Trojan Nuclear Plant
Docket 50-344
License NPF-1

Trojan Reactor Vessel Radiation Surveillance Program

APPENDIX A

HEATUP AND COOLDOWN LIMIT CURVES FOR NORMAL OPERATION

**FIGURE A-3. TROJAN REACTOR COOLANT SYSTEM
HEATUP LIMITATIONS APPLICABLE
FOR THE FIRST 10 EFPY**

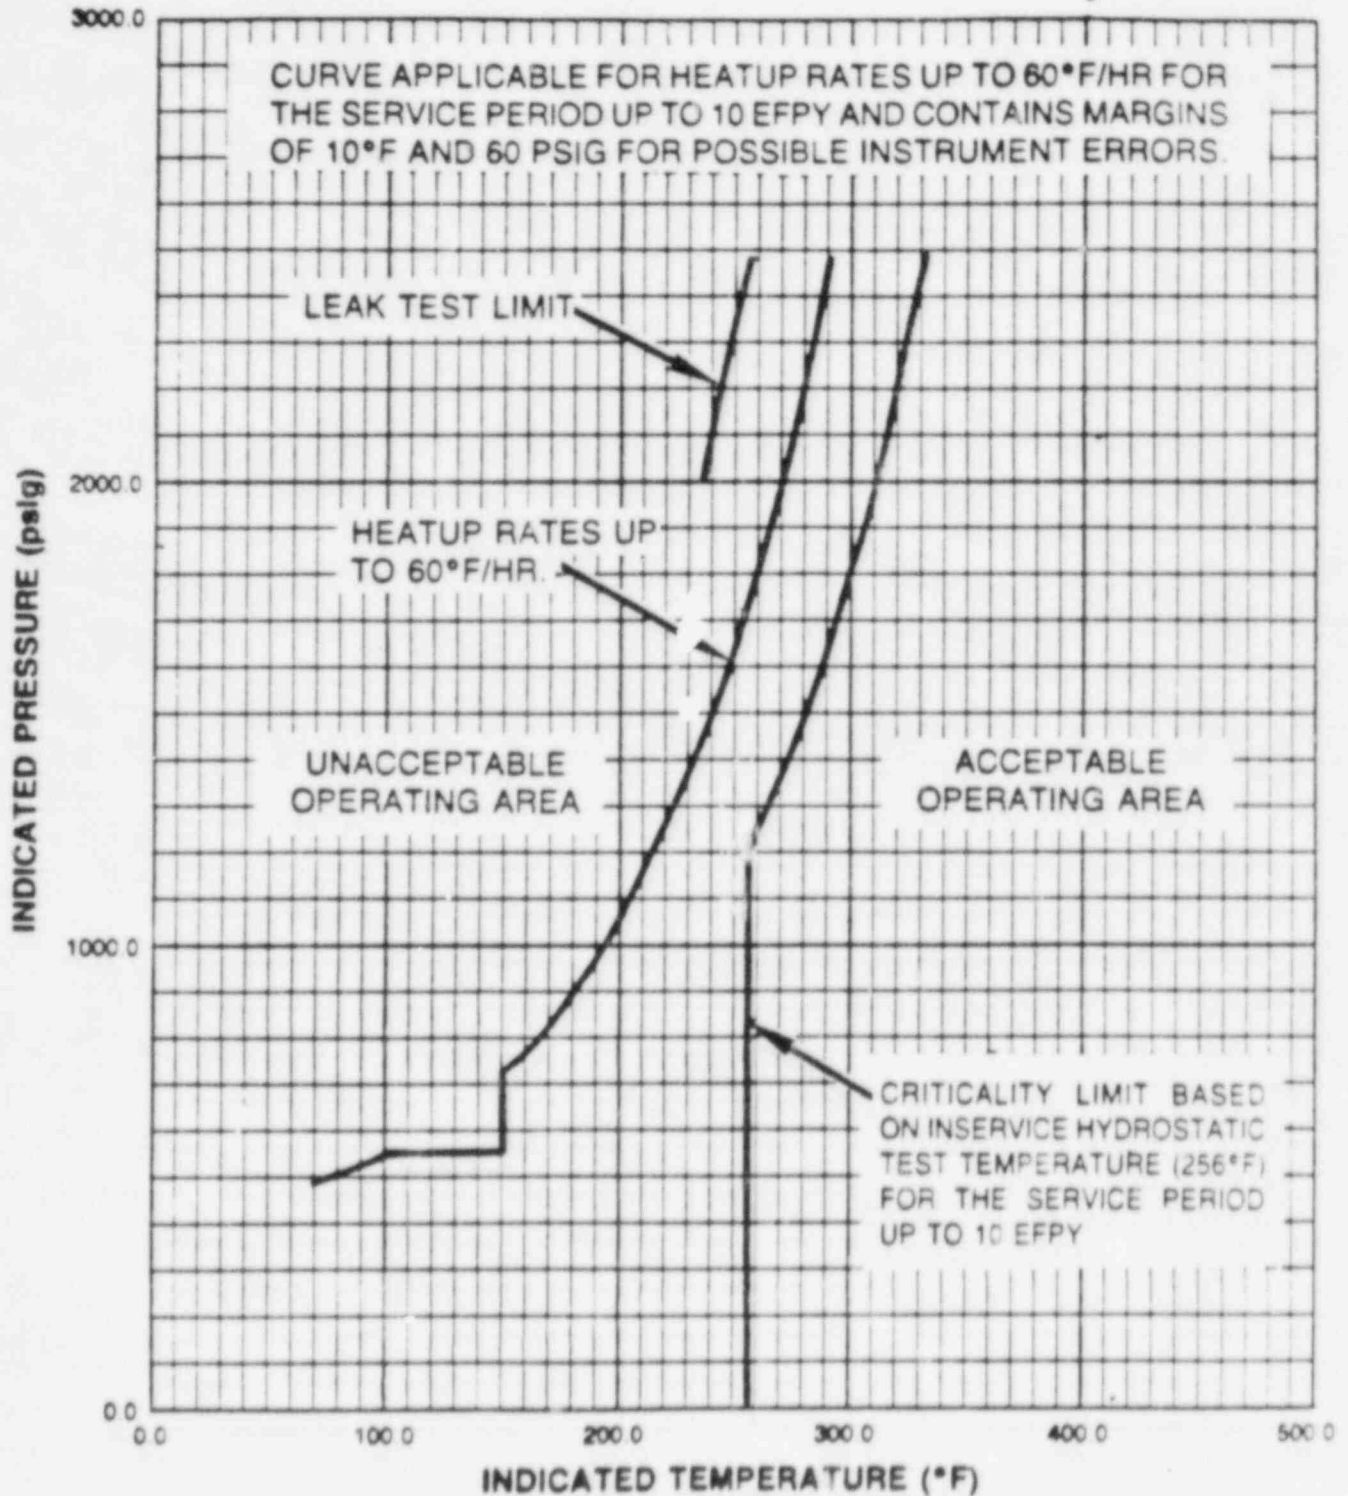
Please note Section 7 and Appendix A of the report identify changes to the surveillance capsule removal schedule and the heatup and cooldown limit curves based on identified changes in RT_{NDT}. The removal schedule and heatup and cooldown curves are contained in Trojan Technical Specifications and are currently the subject of License Change Application (LCA) 99, Revision 2 which you are reviewing. Therefore, we would like to withdraw LCA 99, Revision 2 so that we may incorporate the changes identified in the Capsule X report. A new LCA will then be submitted.

Transition temperature shifts occurring in the pressure vessel materials due to radiation exposure have been obtained directly from the reactor pressure vessel surveillance program. Charpy test specimens from Capsule X indicate that the surveillance weld metal and core region lower shell plate heat No. C5583-1 exhibited shifts in RT_{NDT} of 50°F and 95°F, respectively. These shifts at a fluence of $1.77 \times 10^{19} \text{n/cm}^2$ are well within the appropriate design curve (Figure A-1) prediction. As a result, the heatup and cooldown curves are based on the ΔRT_{NDT} given in Figure A-1 for the most limiting beltline material which is the lower shell plate heat no. B9883-1. The resultant heatup and cooldown limit curves for normal operation of the reactor vessel are presented in Figures A-3 and A-4 and represent an operational time period of 10 EFPY. These limit curves are impacted by the new 10CFR50 rule.

Allowable combinations of temperature and pressure for specific temperature change rates are below and to the right of the limit lines shown on the heatup and cooldown curves. The reactor must not be made critical until pressure-temperature combinations are to the right of the criticality limit line shown in Figure A-3. This is in addition to other criteria which must be met before the reactor is made critical.

The leak test limit curve shown in Figure A-3 represents minimum temperature requirements at the leak test pressure specified by applicable codes. The leak test limit curve was determined by methods of References 2 and 4.
